E5515C-05C

S E R V I C E N O T E

E5515C Wireless Communications Test Set (8960 Series)

Power-On DSP Initialization Failures Require Replacement of the DSP Assembly

Figure 1 – DSP initialization bootup failure during test set power-on.

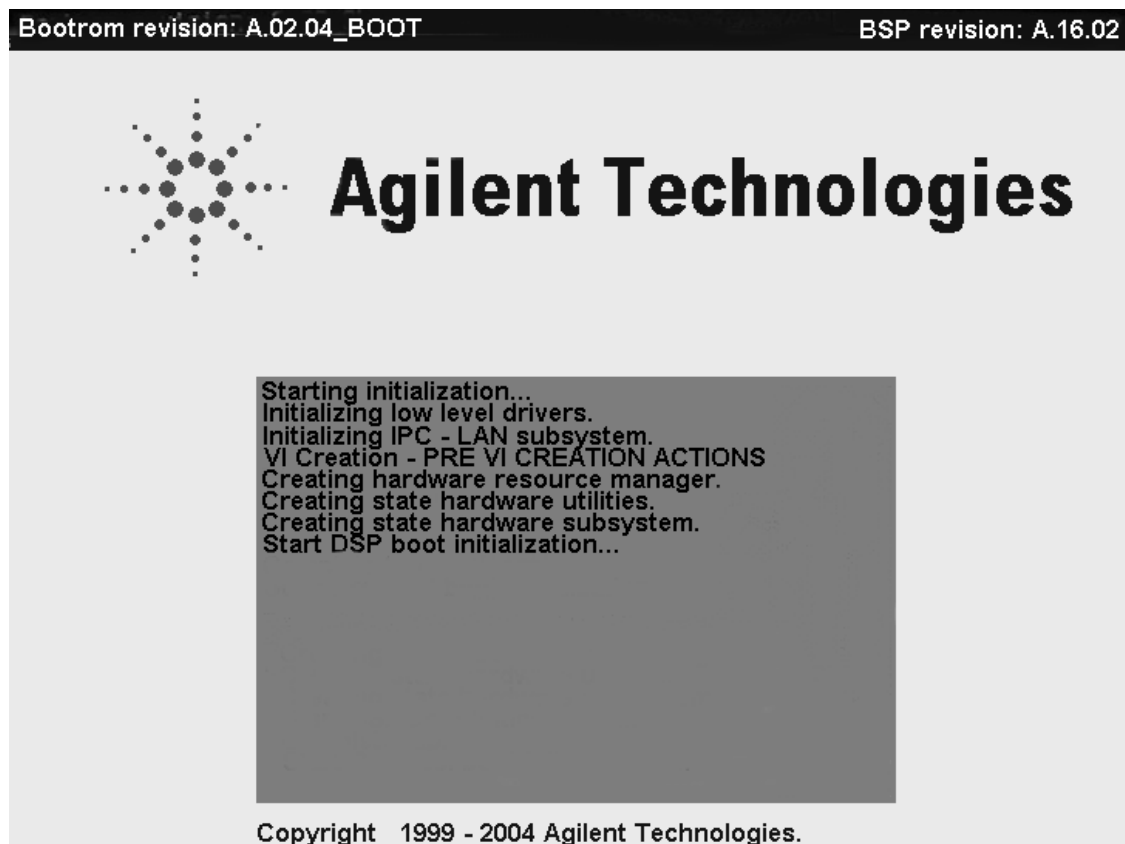
- **Figure 1** shows the typical point in the test set bootup process where the DSP fails to initialize. The bootup process may stop here and then re-boot, or will eventually complete the bootup process after multiple attempts to initialize the DSP assembly.

If the test set fails to bootup correctly, takes longer than normal to bootup, or displays messages noted below, replace the DSP Assembly using exchange repair kit E5515-69843. Verify that the test set boots up and operates normally. Re-calibration is not required.
